From: Nathan McCarty <McCartyN@aks-eng.com>
Sent: Friday, January 05, 2018 8:23 AM
To: Laura Terway
Cc: Chris Goodell; Monty Hurley
Subject: Lot Reductions Proposed Code Revisions
Attachments: 5837 20170807 Lindsay Anne Estates Too - Preliminary Land Use Subdivision Plan.pdf;
5837 20180102 Prelim Plat with New Code.pdf

LINDSAY ANNE
ESTATES TOO
OREGON CITY
OREGON
CLACKAMAS COUNTY TAX MAP 3-2E-18
TAX LOT 1400

PRELIMINARY SUBDIVISION
PLAT (PER PROPOSED
CODE CHANGES)

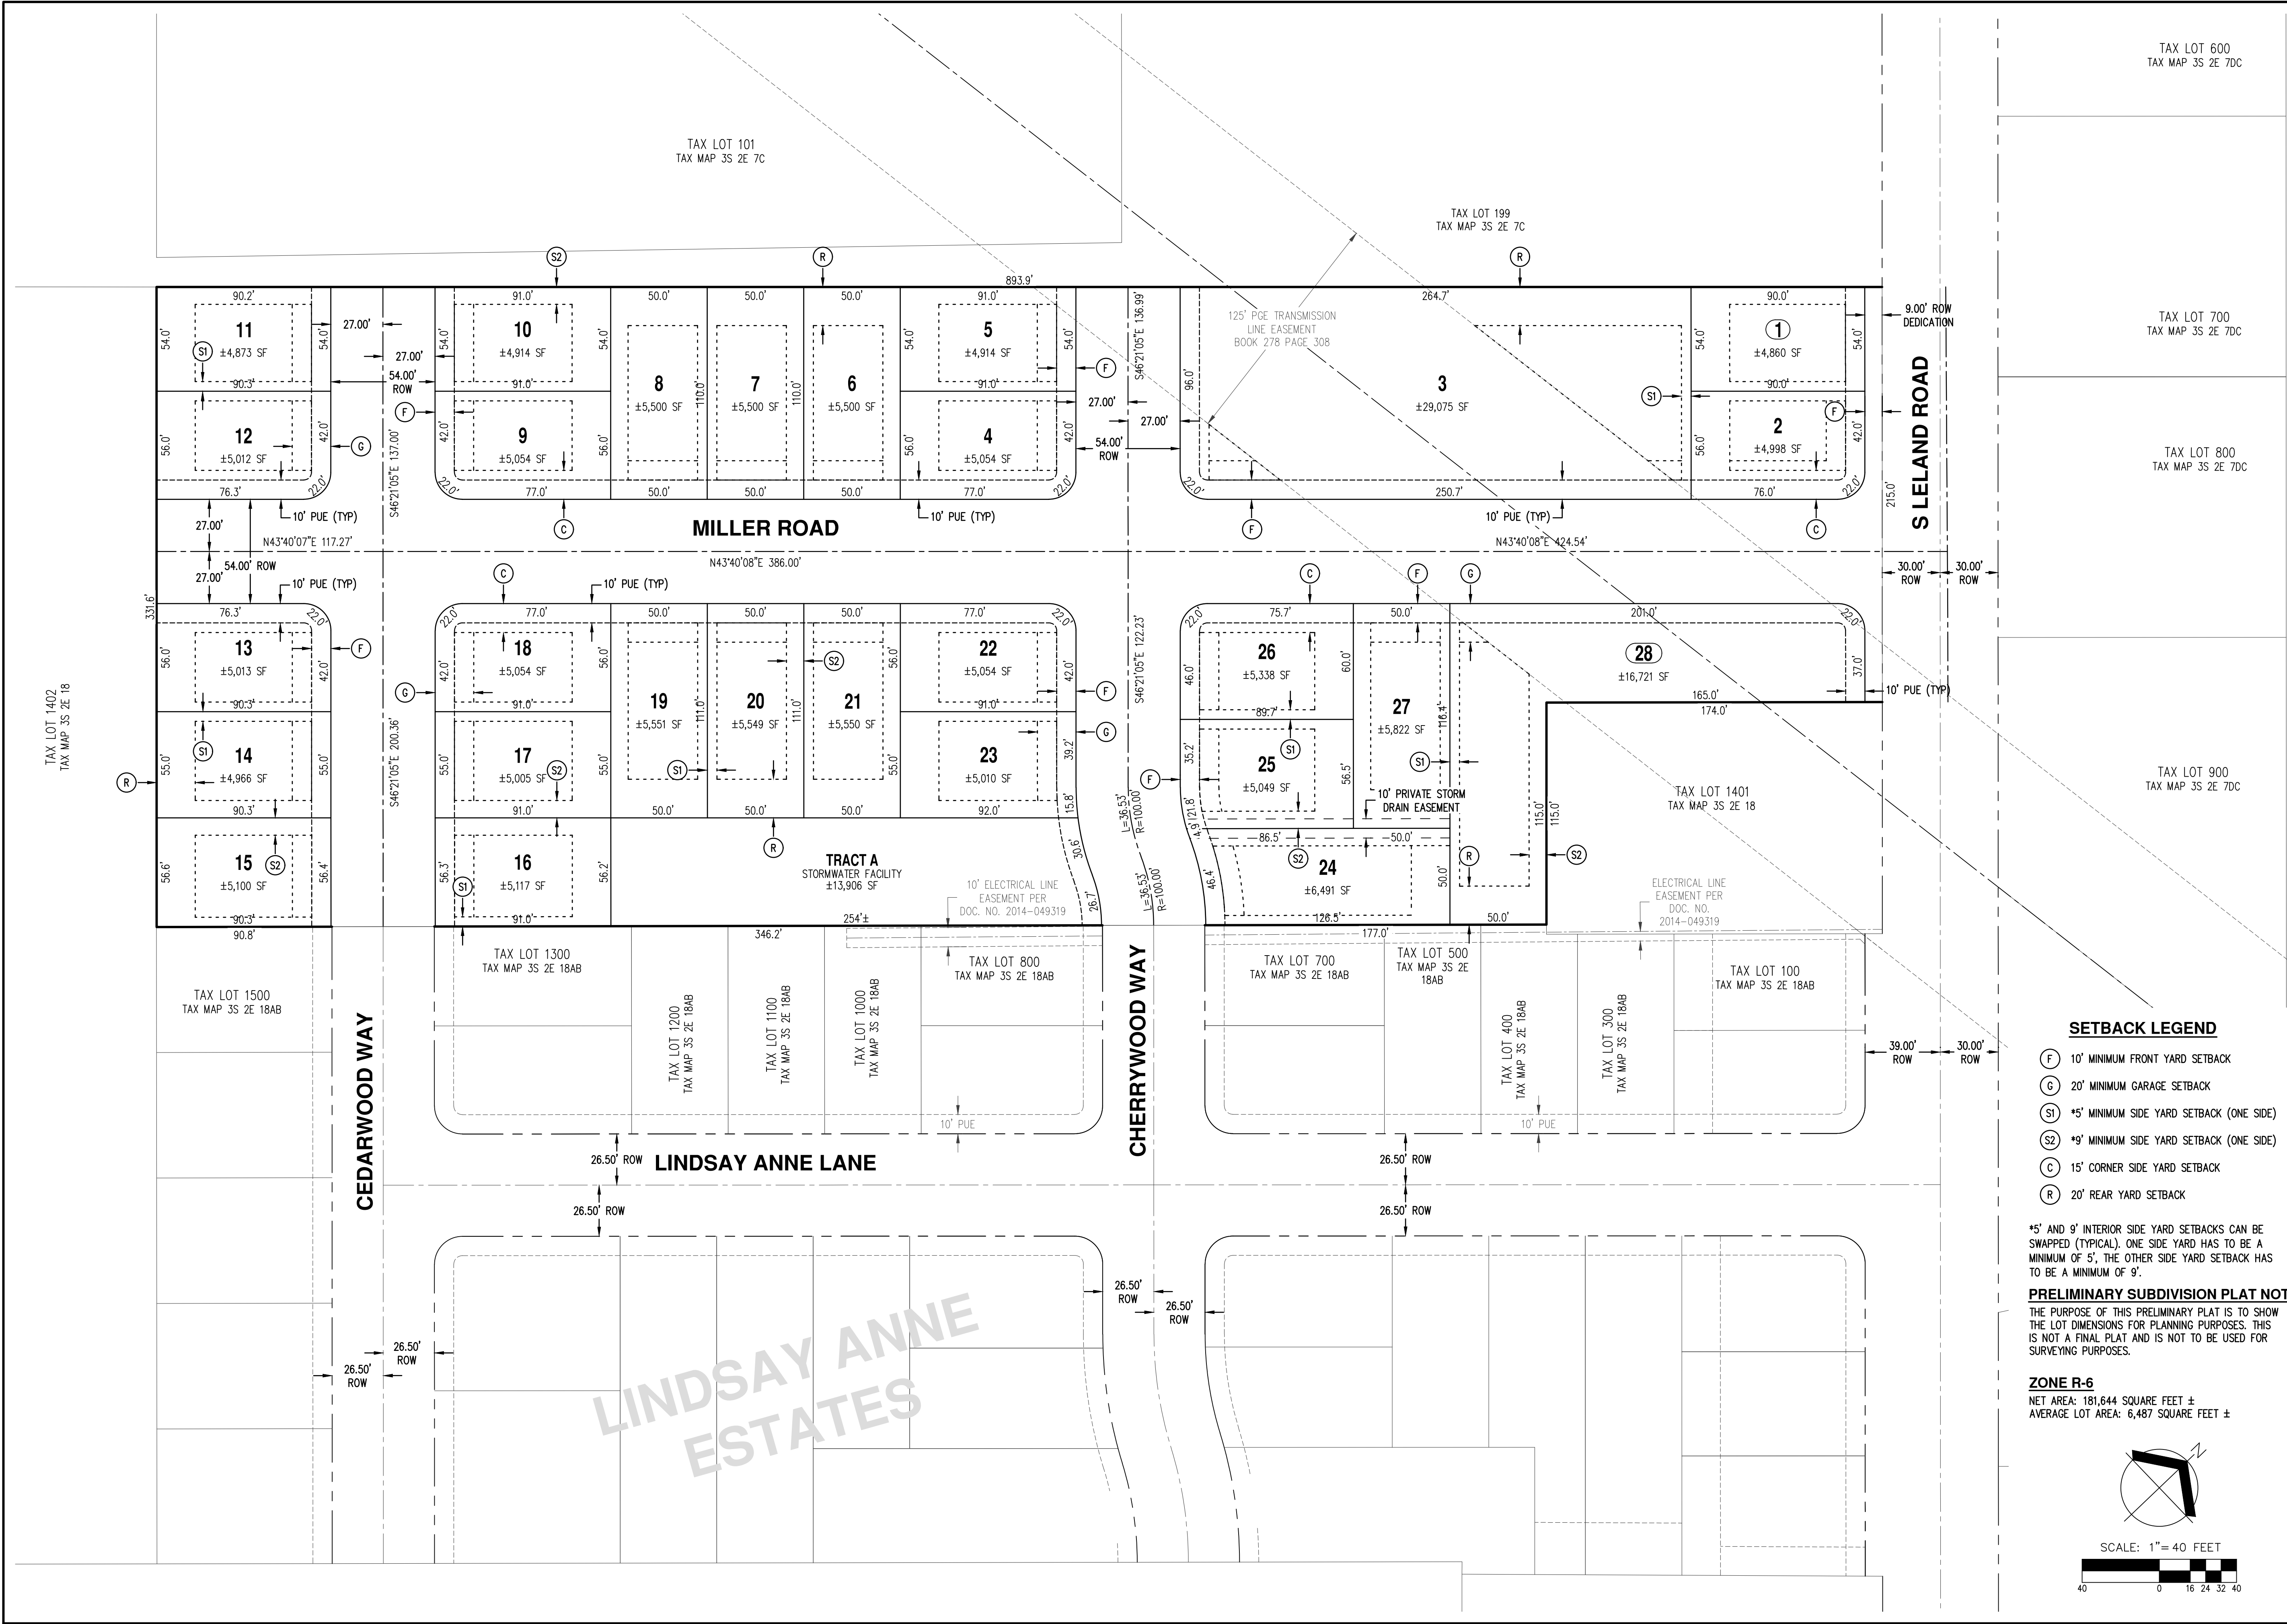
To summarize what was discussed at the stakeholder's meeting yesterday morning, if the draft code language was adopted by the City and effective and we didn't already have the Lindsay Anne Estates Too application in/approved, it would have reduced the density by 5 lots. See attached. It wouldn't meet the City's minimum density requirement unless the PGE easement was taken out of the site's net developable area for the calculation.

If the 125' wide PGE easement was taken out of the site's net developable area for the calculation (and considered unbuildable), lots 3 and 28 would be negatively affected.

It is the change of the code from twenty percent less than the required minimum lot area to ten percent less that would have reduced the number of lots on this project by 5 lots.

PRELIMINARY SUBDIVISION
PLAT WITH BUILDING
SETBACKS

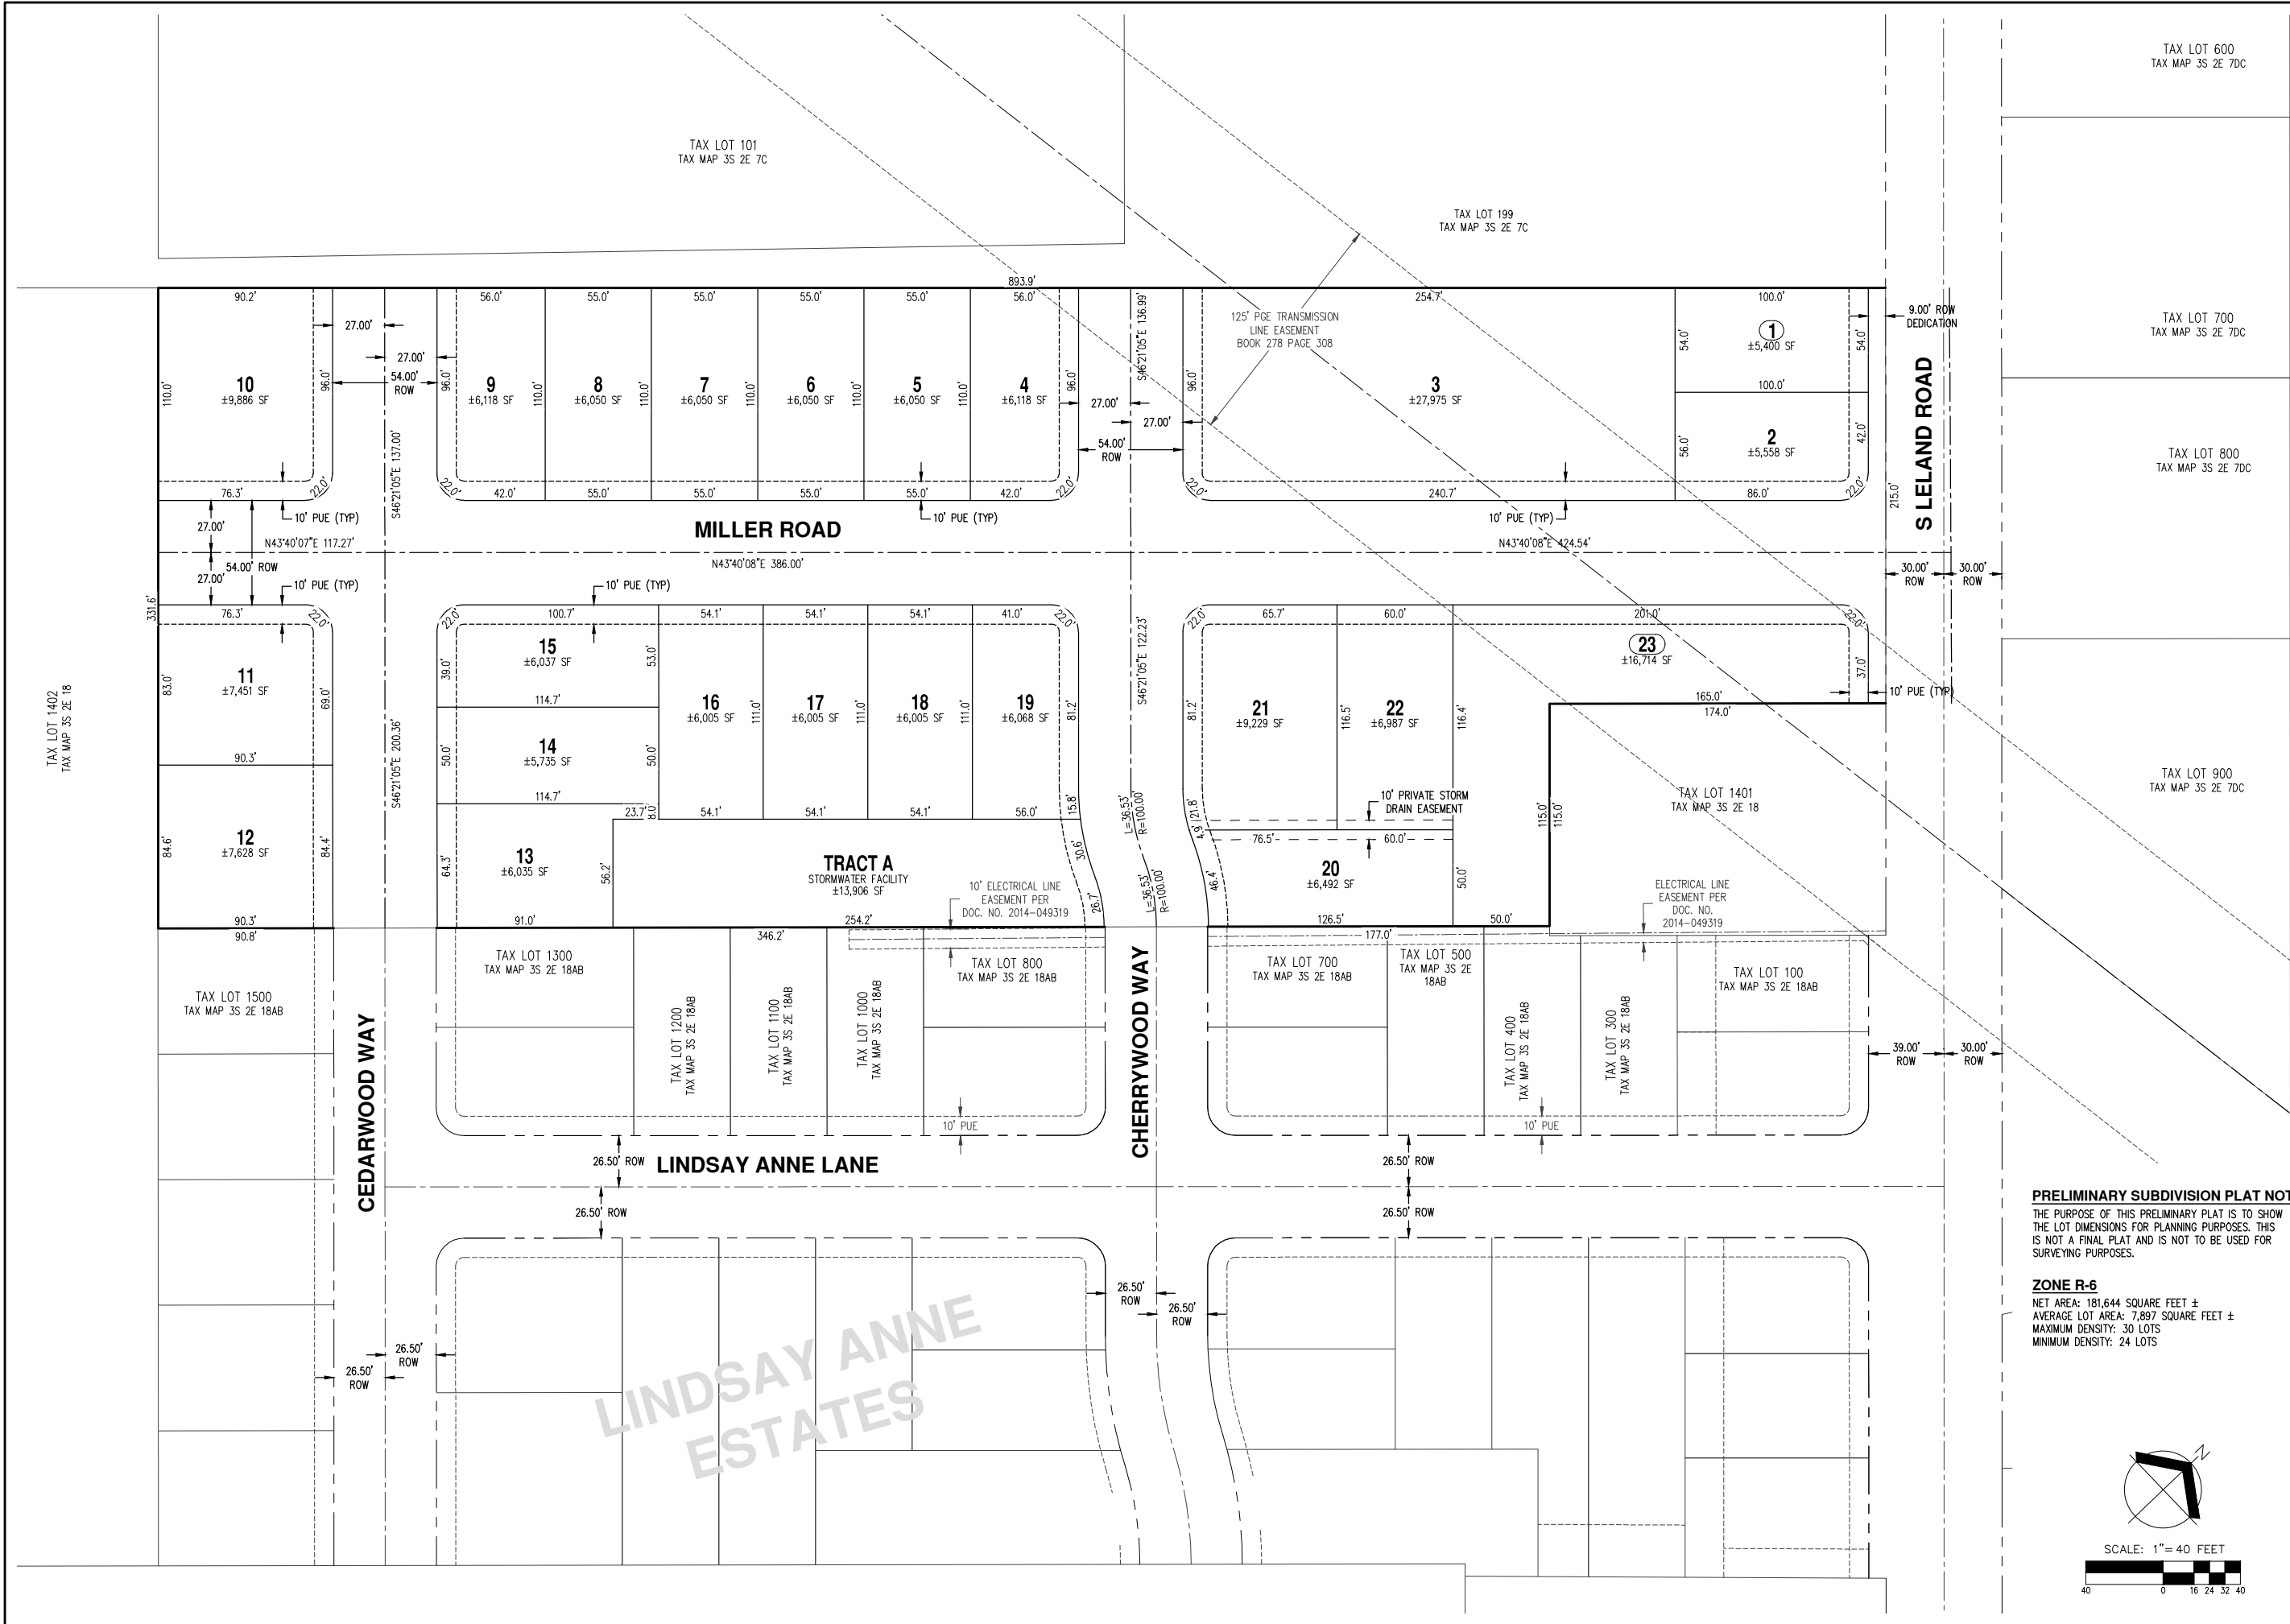
We also discussed looking at other potential layouts of Lindsay Anne Estates Too. After looking into it, changing the "Up to 25% of the lots in a subdivision..." to 50% or all (100%) would not have affected this layout as only two of the lots were less than 6,000 S.F.
